CONTRACT CHANGE ORDER NO. ____
SHEET ___ OF ___

MARK	DATE	DESCRIPTIONS	BY	CH'D	CCO#
		REVISIONS			
1	07/31/09	LONGITUDINAL SHEAR PLATE	DT	GB	122

SAN FRANCISCO OAKLAND BAY BRIDGE
EAST SPAN SEISMIC SAFETY PROJECT
SELF-ANCHORED SUSPENSION BRIDGE
(SUPERSTRUCTURE & TOWER)

TYPICAL GIRDER DETAILS NO. 3

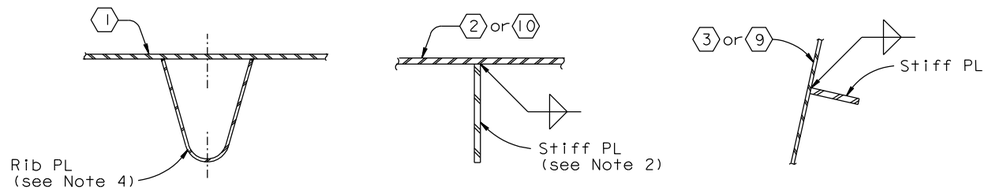
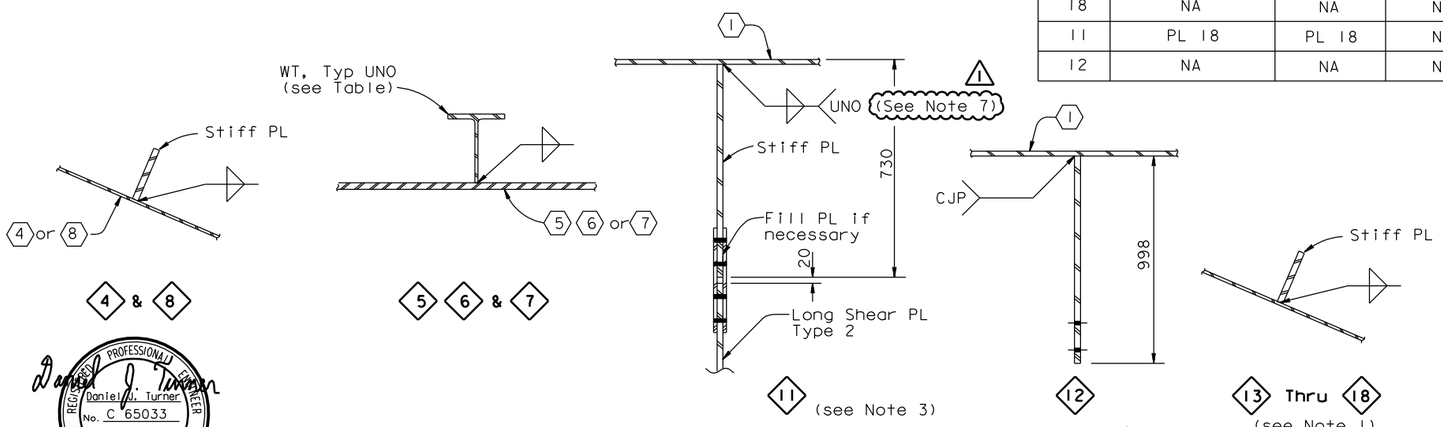
1. For stiffener layout in girder section Type 1B, see "Partial Typical Section No.3" sheet. For stiffener layout of east transition girder, see "Girder At East Transition" sheets.
2. Stiffener types 2 and 10 shall be ASTM A709M HPS Grade 485W steel.
3. For details of stiffener type 11 not shown, see "Girder At East Transition No.9", "Girder At East Transition No.15" and "Girder At East Transition No.16" sheets.
4. For details of stiffener type 1, see "Typical Girder Details No.4" sheet.
5. For details of longitudinal shear plates, see "Typical Girder Details No. 7" sheet.
6. For details of stiffener type 12 not shown, see "Girder At East Transition No. 5", "Girder At East Transition No. 6" and "Girder At East Transition No. 17" sheets.
7. (1) This weld shall be CJP from PP112 to PP128.3.

TYPICAL GIRDER DETAILS NO. 5

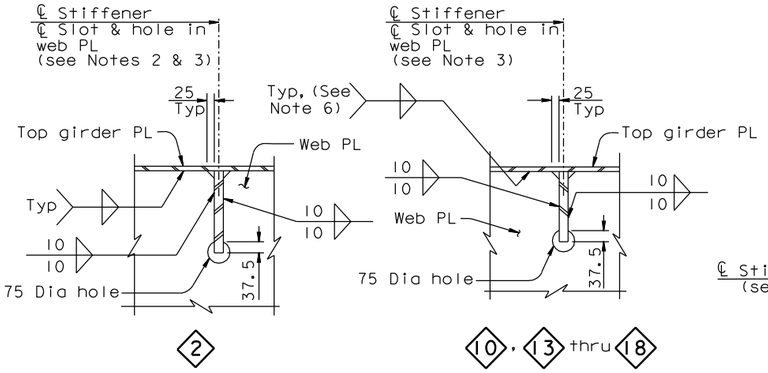
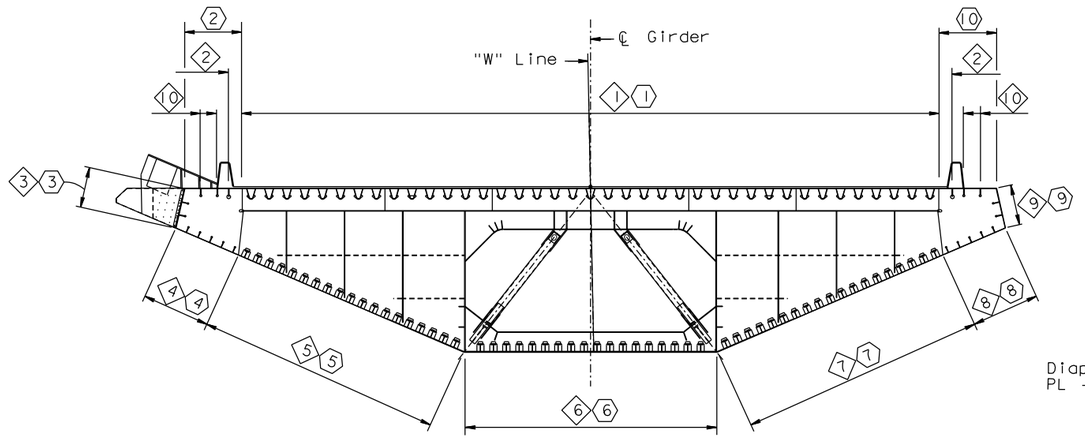
MARK	DATE	DESCRIPTIONS	BY	CH'D	CCO#
3	07/31/09	LONGITUDINAL SHEAR PLATE	GB	DT	122
2	02/20/09	SUSPENDER BRACKETS	GB	DT	104
1	07/26/06	ADD STIFFENER TYPES 13 THRU 18	GB	NV	22

TYPICAL GIRDER DETAILS NO. 7

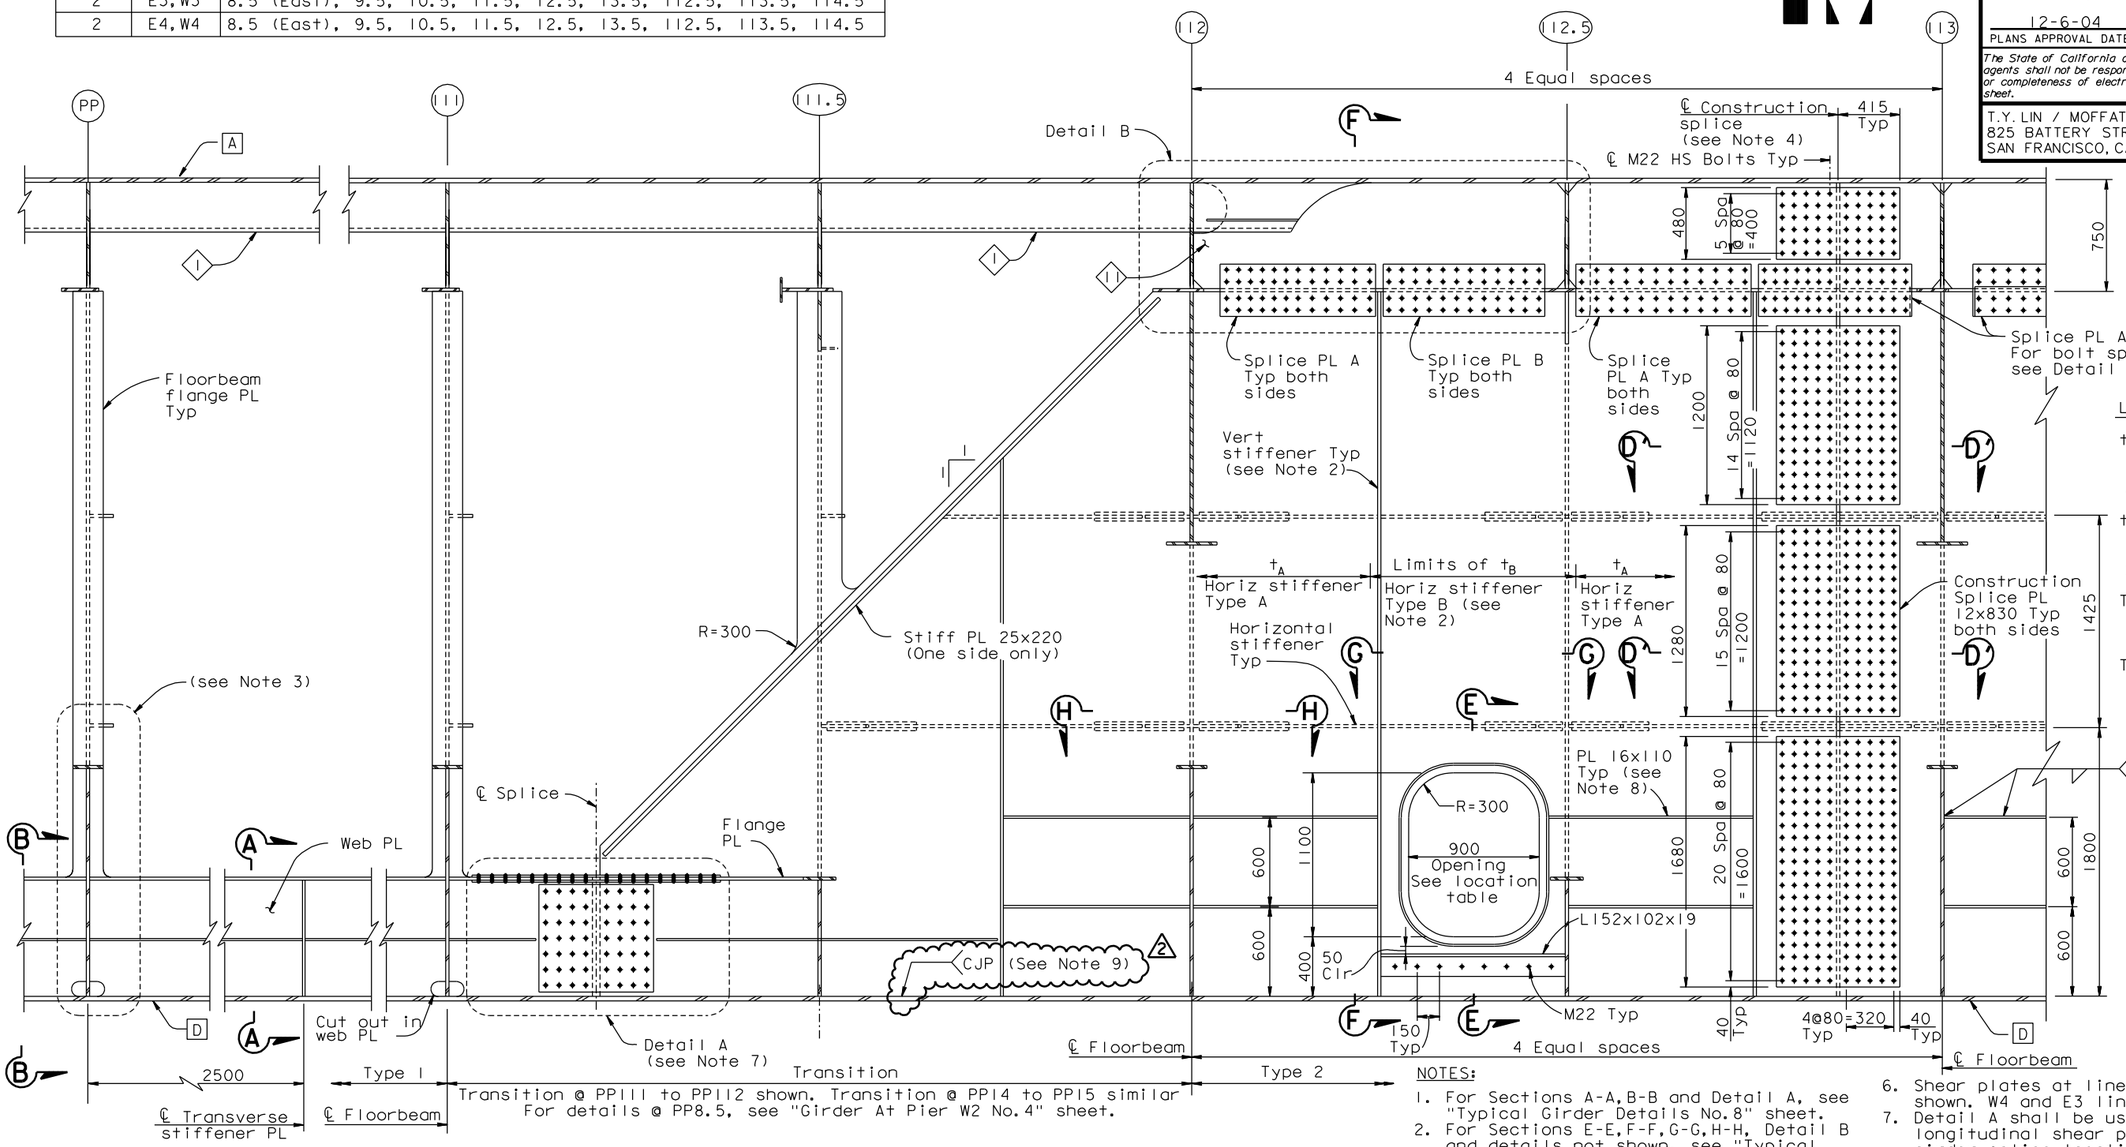
2 9. The Longitudinal Shear Plate to Girder Face "D" weld shall be a CJP from the CL Splice near PP111 to PP128.7.

MARK	DATE	REVISIONS	BY	CH'D	CCO#
2	07/31/09	LONGITUDINAL SHEAR PLATE	DT	GB	122
1	07/30/07	HINGE A REACTION-SHEAR PLATES	DT	GB	50

TYPICAL GIRDER DETAILS NO. 9

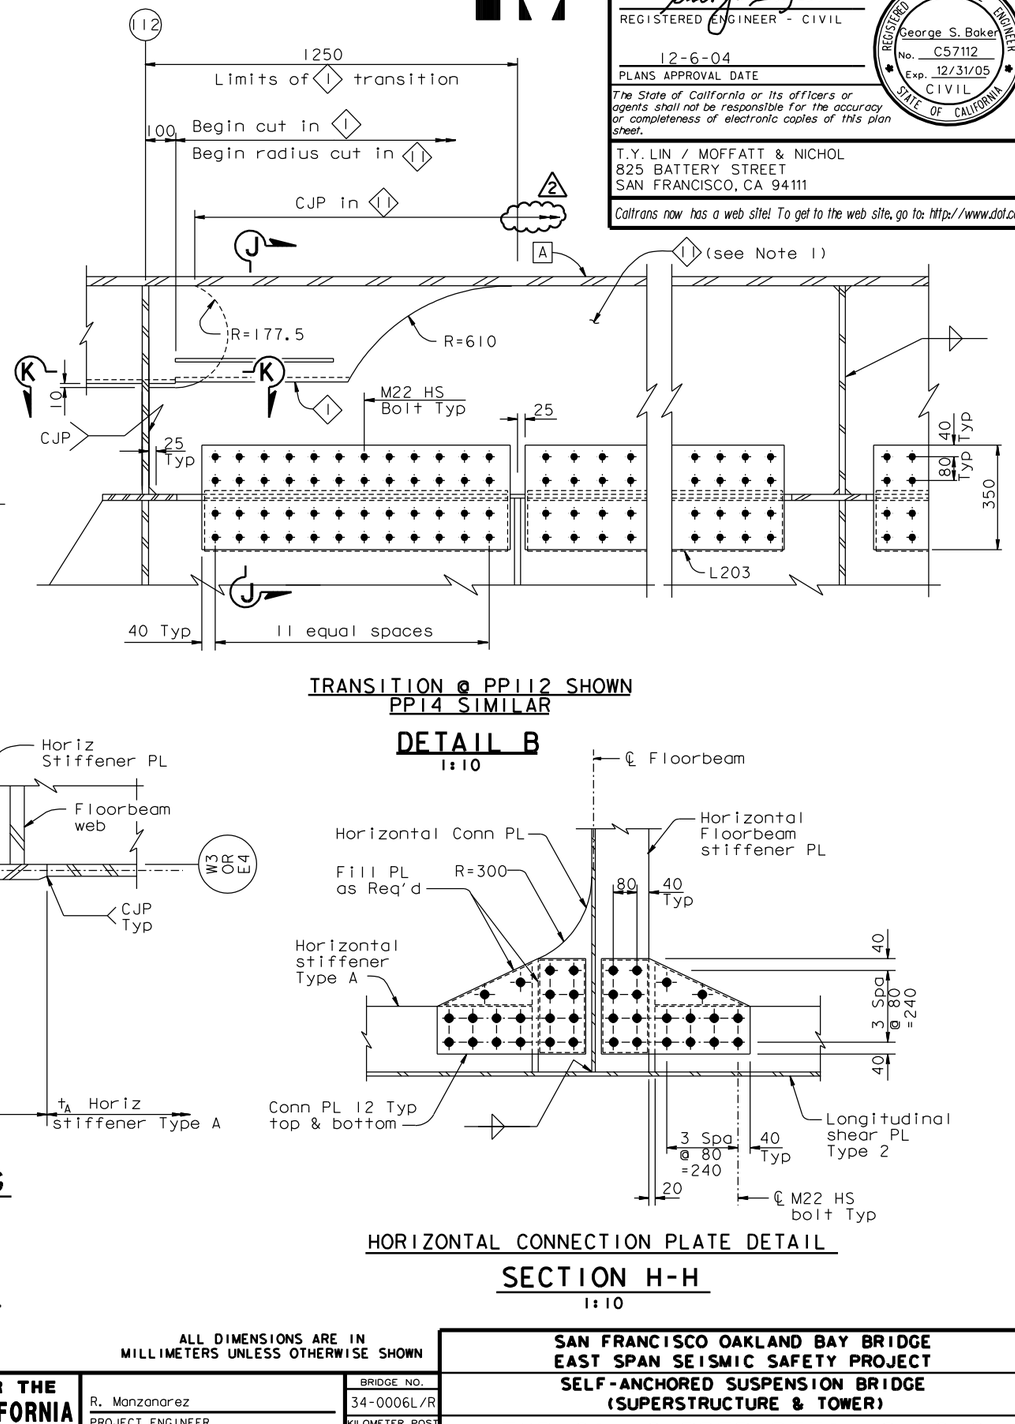
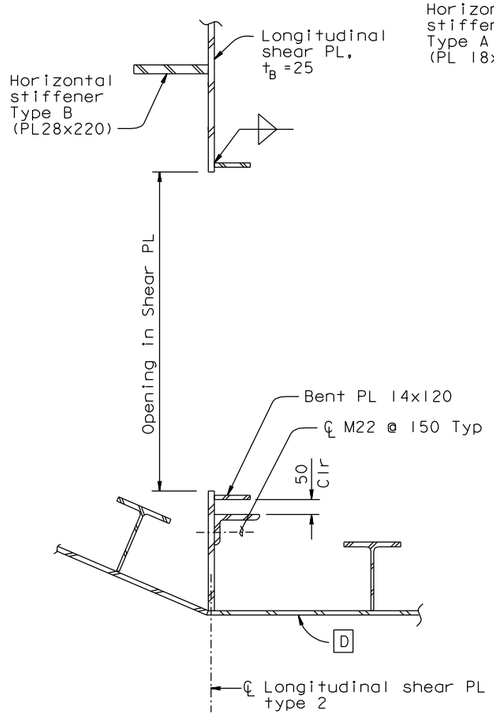
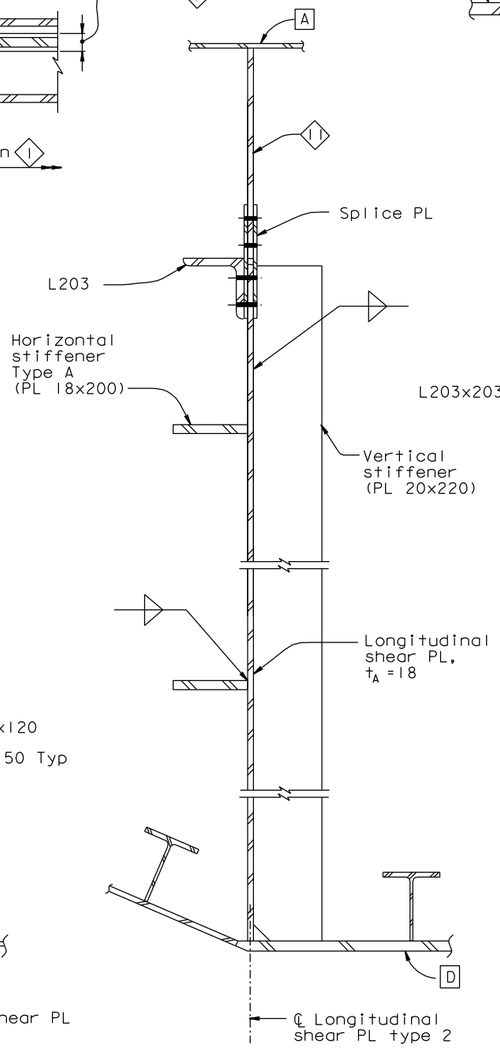
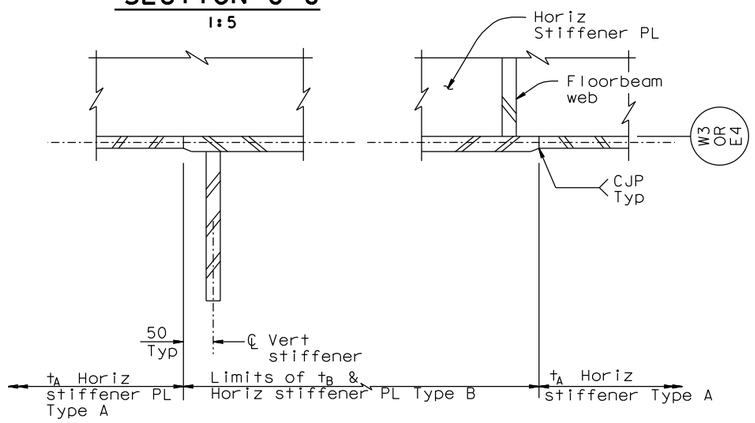
MARK	DATE	DESCRIPTIONS	BY	CH'D	CCO#
2	07/31/09	LONGITUDINAL SHEAR PLATE	DT	GB	122
1	07/30/07	HINGE A REACTION-SHEAR PLATES	DT	GB	50

GIRDER AT PIER E2 NO.2

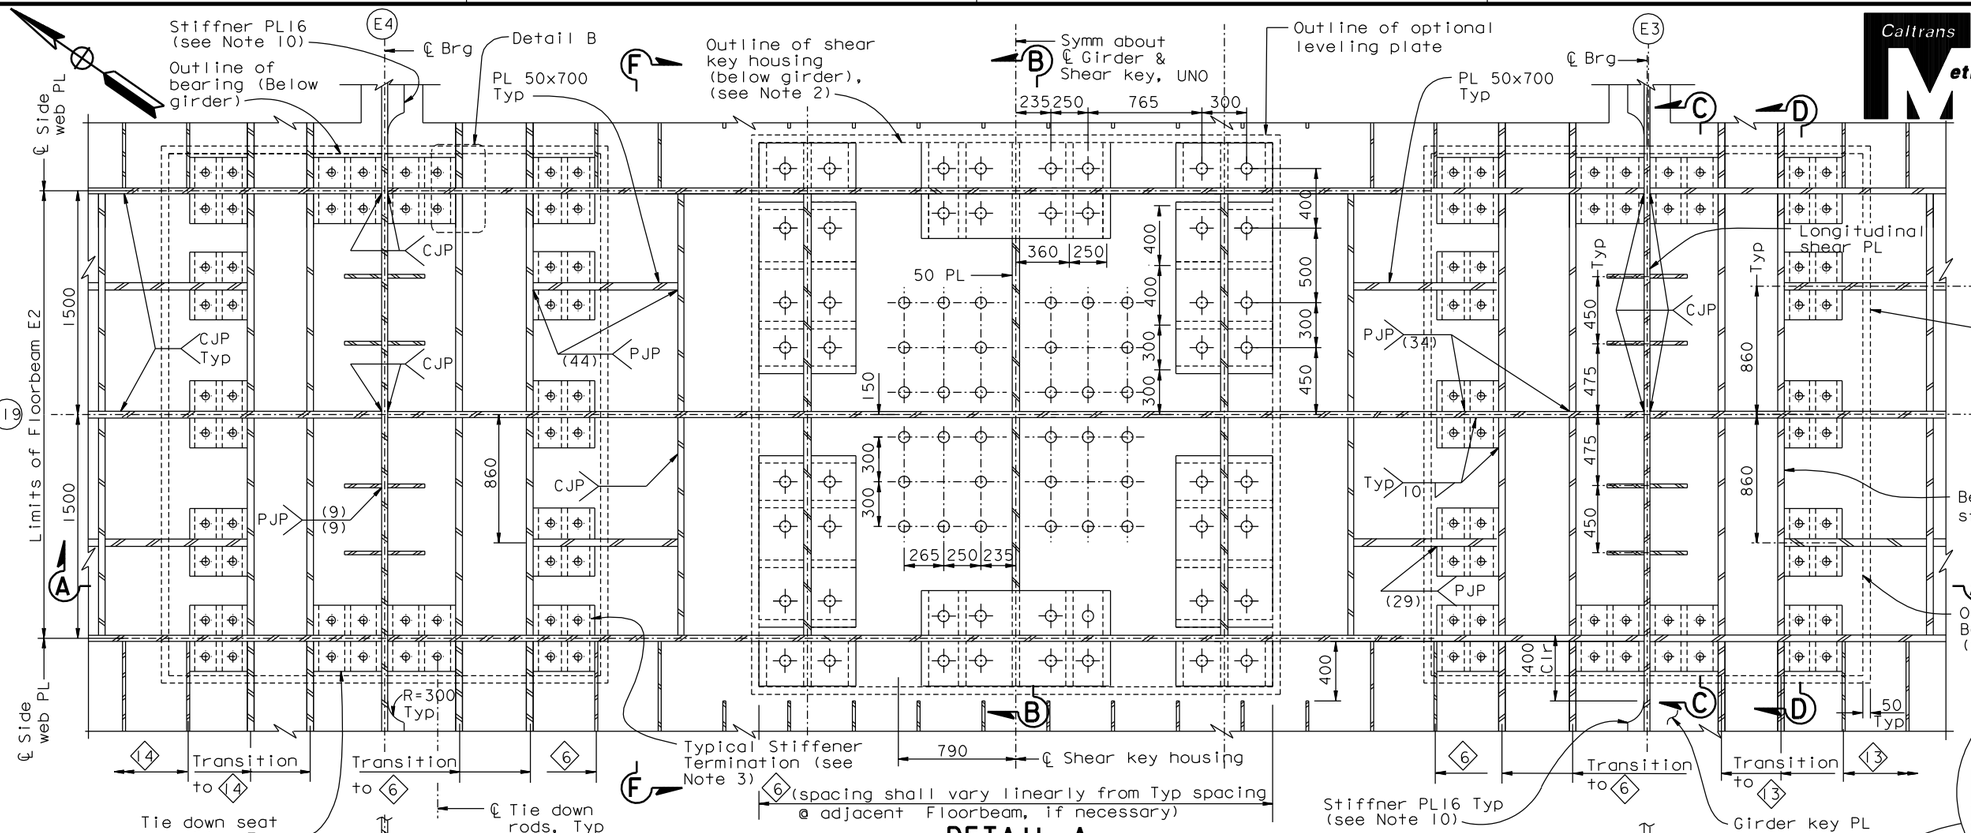
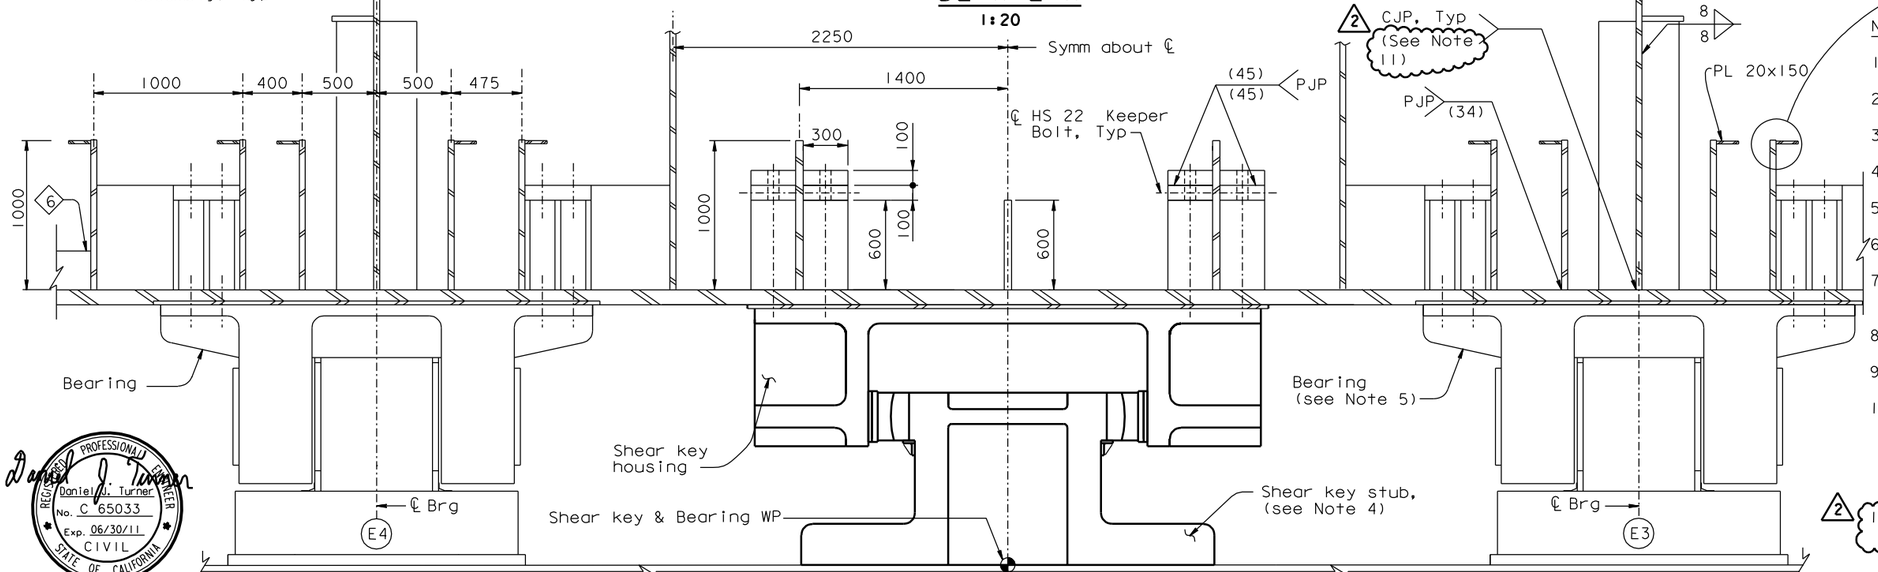
2 11. For extent of CJP weld, see Note 12 on "Typical Girder Details No.7" sheet.

MARK	DATE	DESCRIPTIONS	BY	CH'D	CCO#
		REVISIONS			
2	07/31/09	LONGITUDINAL SHEAR PLATE	DT	GB	122
1	07/30/07	HINGE A REACTION-SHEAR PLATES	DT	GB	50
